Re: Rapiscan AIT System Radiation Survey Reporting

Rapiscan systems	Secure 1000 Radiation Emission Measurement	FORM R-0646-1 (Single Pose)
----------------------------	---	------------------------------------

**R-0646-1 Addendum
(Documentation Errors)**

Product Name	Secure 1000SP (Single Pose)
Serial Number	S51037002
Radiation Emission Measurement	Radiation Survey Dated: 10/28/2010
RSO Initials

1. In Beam Dose Measurement: Survey Table. 1

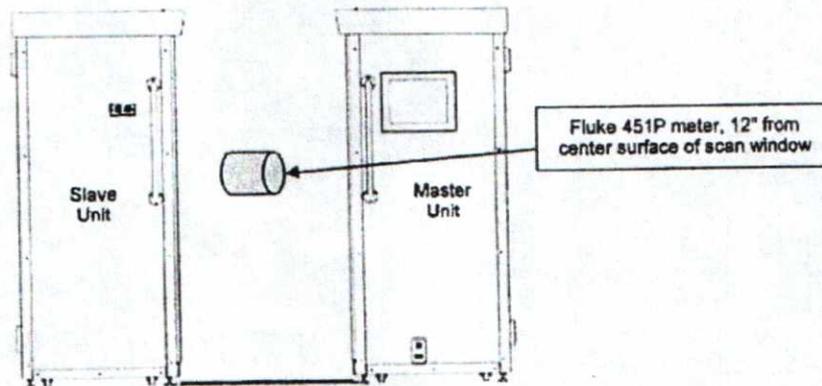
1. TABLE 1: Incorrect presentation of data in Column 3 for Measured Exposure. Indicated values are too low, normal values are 1uR and above. A probable source of error may be due to the Technician incorrectly positioning the survey meter. These values were then used incorrectly to determine the Effective Dose in Column 6.
2. TABLE 2: Incorrect presentation of data in Column 6 for Dose Equivalent. The correct value should be 1.8 uRem.
3. Based on review of survey by RSO, RSO determined that Technician incorrectly marked the fail check box.

The service technician should attend refresher training with an emphasis on measurement techniques.

The source of the data error cannot be determined on the face of this survey. This system should be re-surveyed.
